**BAYTRONICS
CORPORATION**

TO: All Service Departments
FROM: Walter E. Kaelin, V.P. Engineering
DATE: March 20, 1980
SUBJECT: Mariner 80, Involuntary reverting to channel 16.

Figure 13 Interface Schematic

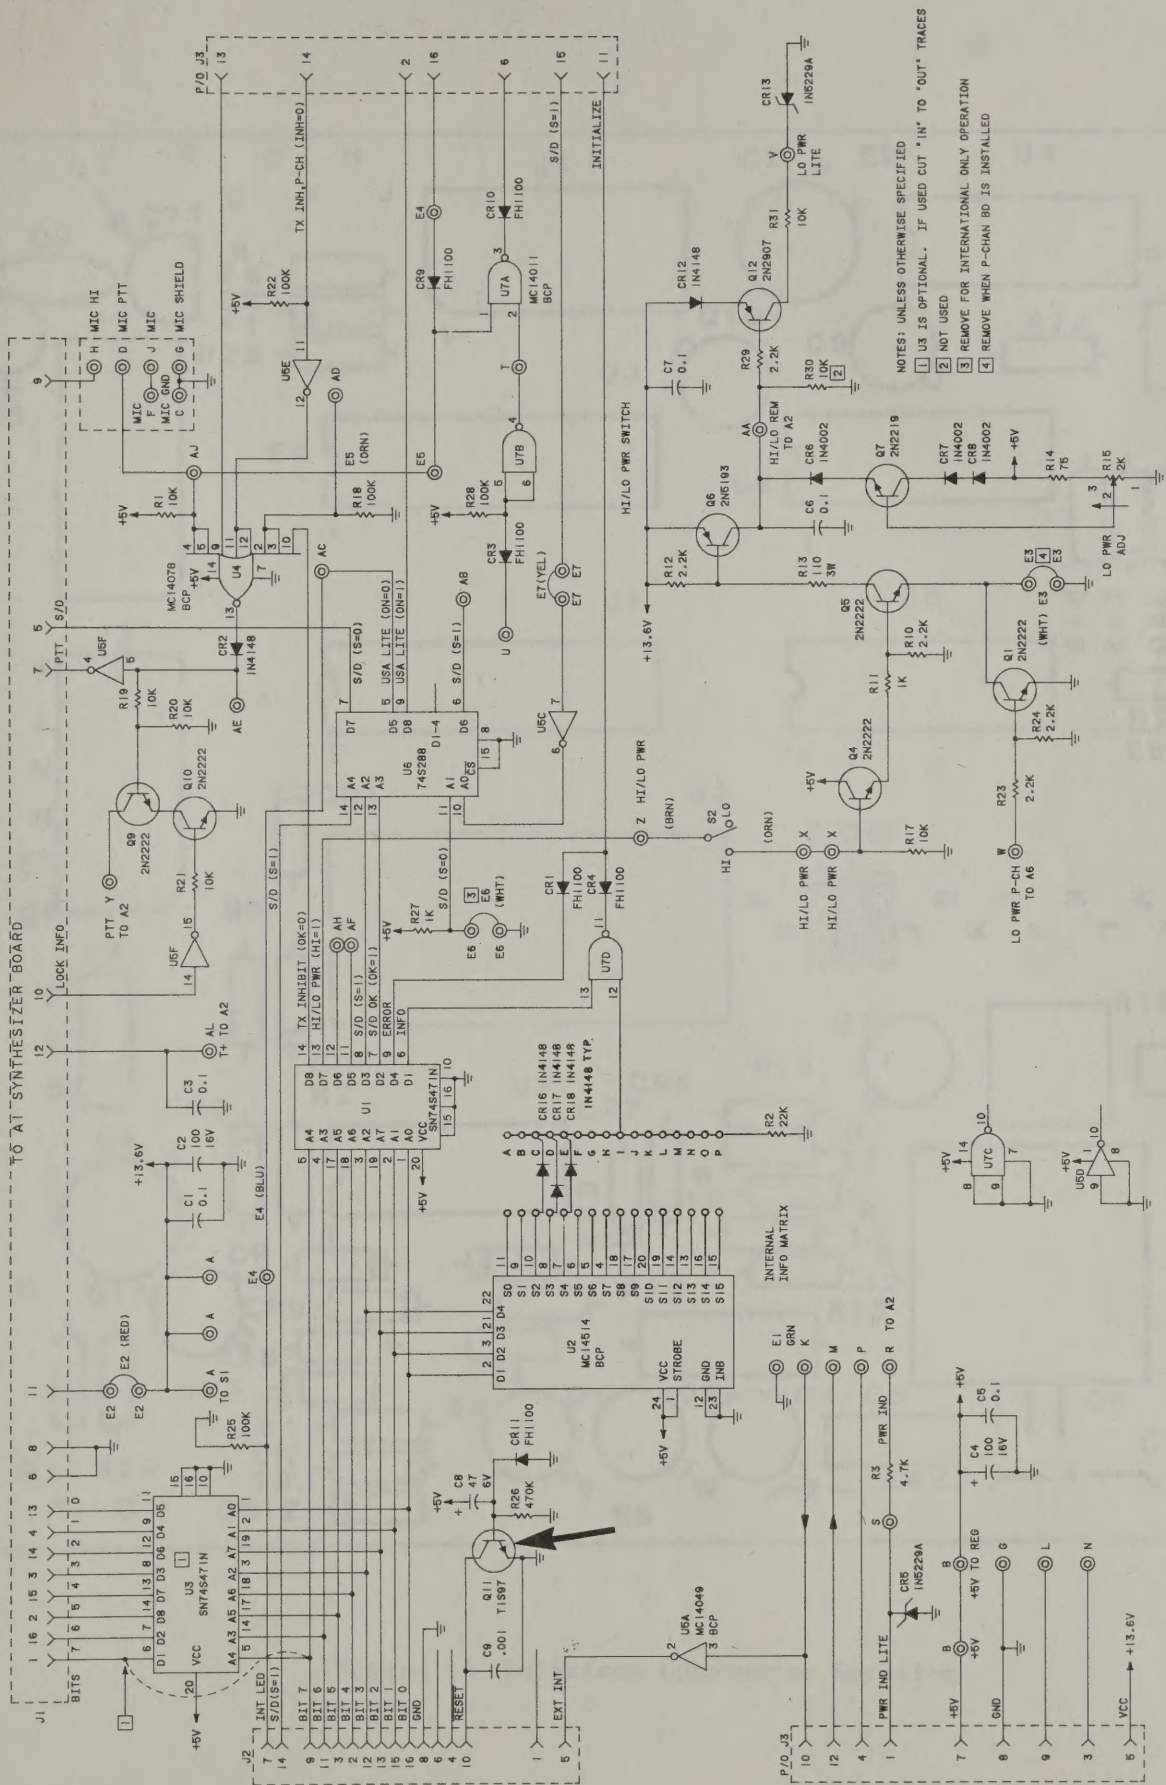
When installed in proximity of a strong R.F. field, it has been noted that certain Mariner 80 VHF radiotelephones, Serial Numbers 2000 and above, can involuntarily revert back to channel 16 from the operating channel. The R.F. field is usually from a 1 KW HF transmitter, but can sometimes be from a transmitting VHF antenna that is close to the Mariner 80.

The fix is simple: merely remove by clipping out Transistor Q11 (Type TIS97) on the A4 Interface printed circuit board. All Mariner 80's shipped since January 15, 1980 have already been modified at the factory.
